Decision Note

Title: 4 Holdsworth Street – SGN2500072 – Wall Sign

To approve a wall sign at 4 Holdsworth Street.

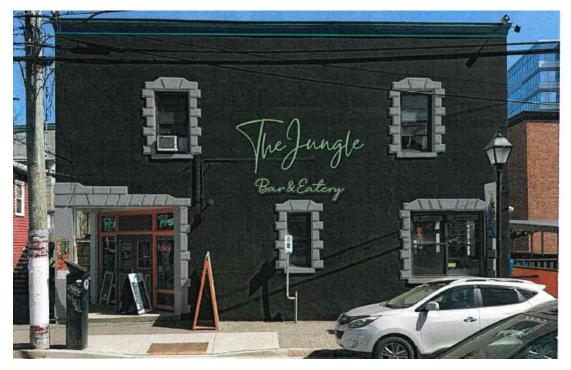
The application is for a green and black LED-lit sign that reads "The Jungle Bar & Eatery". This wall sign is proposed for the façade facing George Street (see image below).

The proposed wall sign measures approximately 5.7 square metres, which exceeds the maximum size permitted. In accordance with section 59 of the By-Law, the Built Heritage Experts Panel may recommend to Council the acceptance of non-conforming signs whose design or situation merit it. Council may accept or reject the recommendation.

The Heritage Panel reviewed this application at its August 6, 2925 regular meeting and recommended Council approve the wall sign, and recommended the sign be raised further above the lower central window and positioned centrally between the three windows highlighted in yellow in the image below. Staff agree with this recommendation.

That Council approve the wall sign at 4 Holdsworth Street, which exceeds the maximum size of 3 square metres, provided the sign be positioned centrally between the three existing windows.
